DEVIATION REQUEST AND DECISION FORM

Project Name : Eagleview Subdivision
 Schedule No.(s) : 5226000001, 5226000001
 Legal Description : N2NW4 EX WLY 620.0 FT SEC 26-12-65,S2NW4 EX WLY 620.0 FT SEC 26-12-65

2.3.8.A Roadway Terminations - Cul-de-Sacs

Deviation No. 2*

Deviation Exhibit

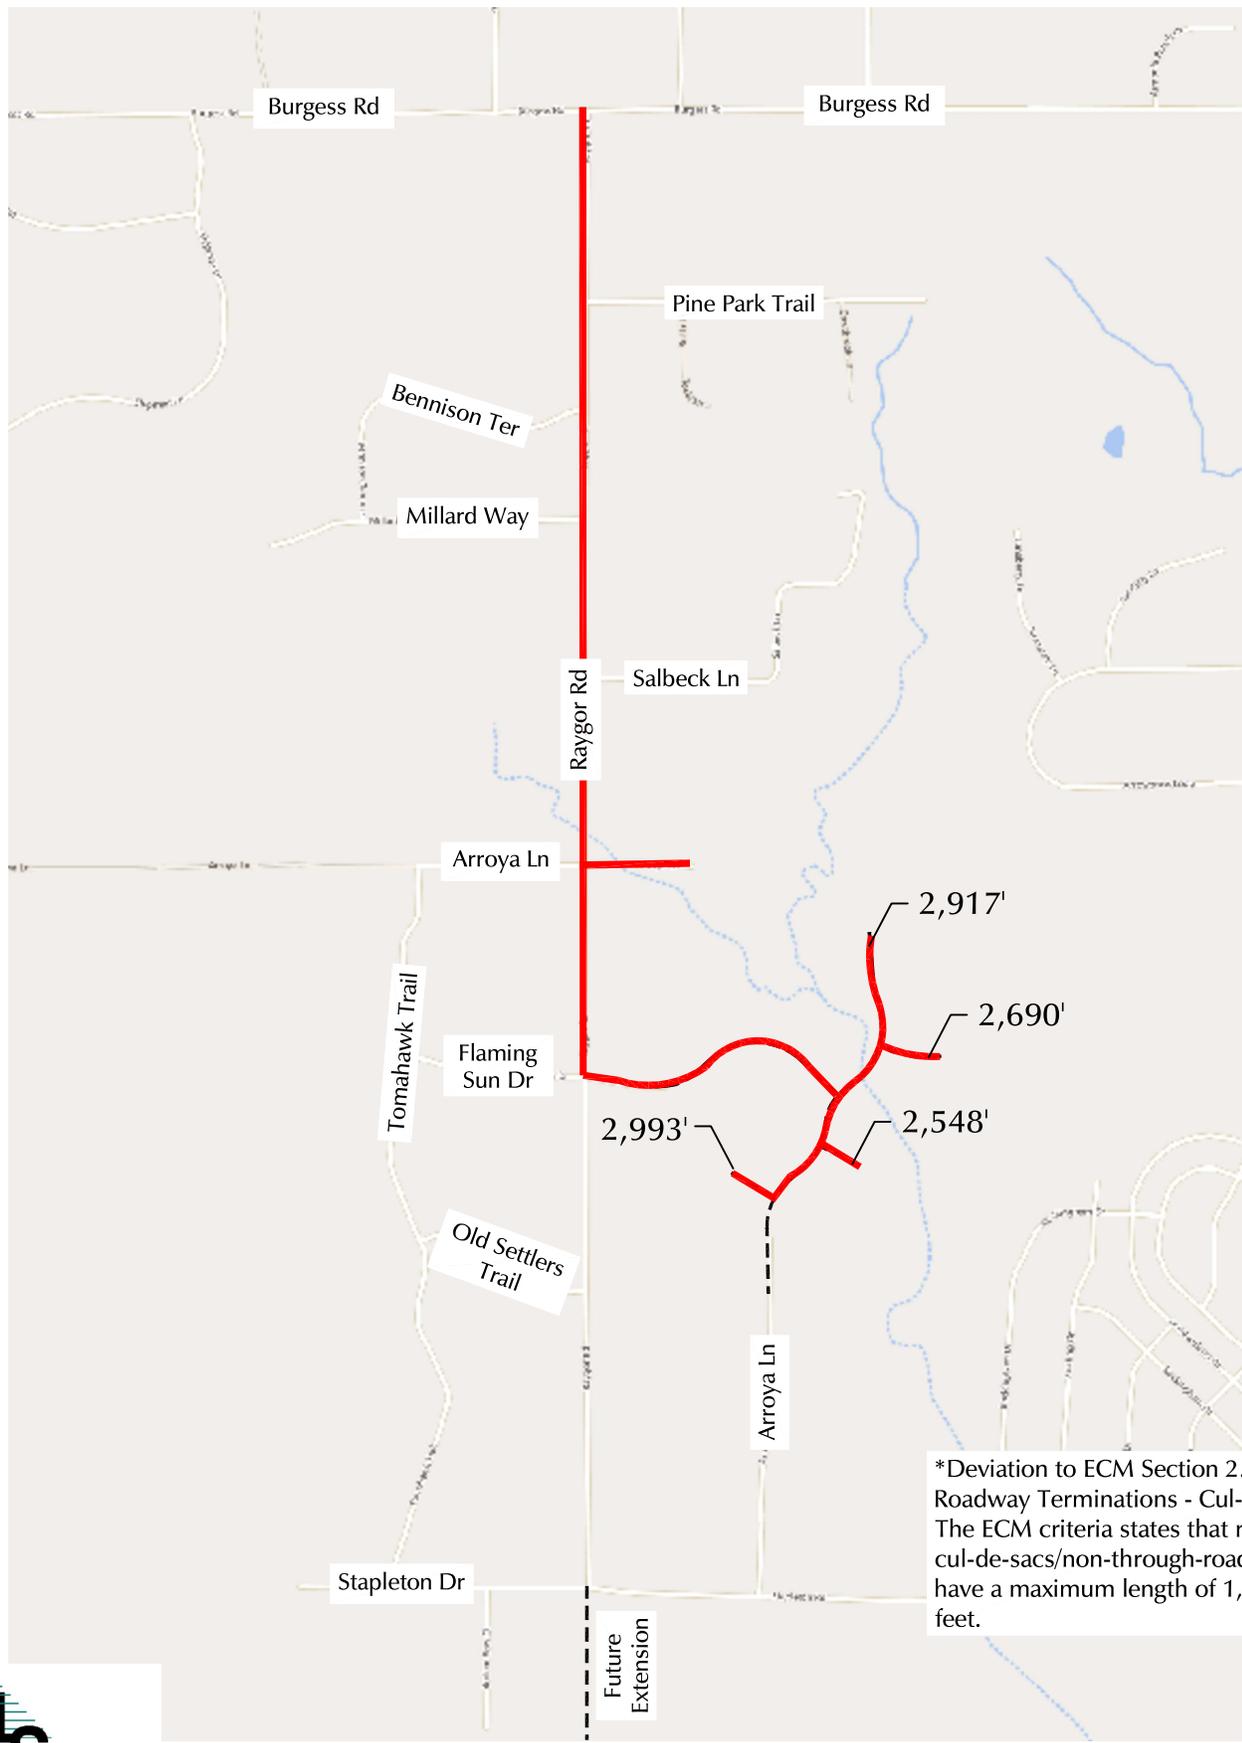
Update cul-de-sac names per the preliminary plan

Remove last bullet point.

A secondary emergency access is required. The applicant needs to approach the developer of Paintbrush Hills Fil 14 to acquire a temporary access easement for a secondary emergency only access or any other land owner in the vicinity such as the church property to the south west the property to the west on Arroya Ln to may be able to provide a secondary emergency access.

Update. See comment on the previous page.

An emergency access is needed as the interim condition.

remove 1st bullet point. Letter must be included with the deviation request

Identify the timing for these future connection.
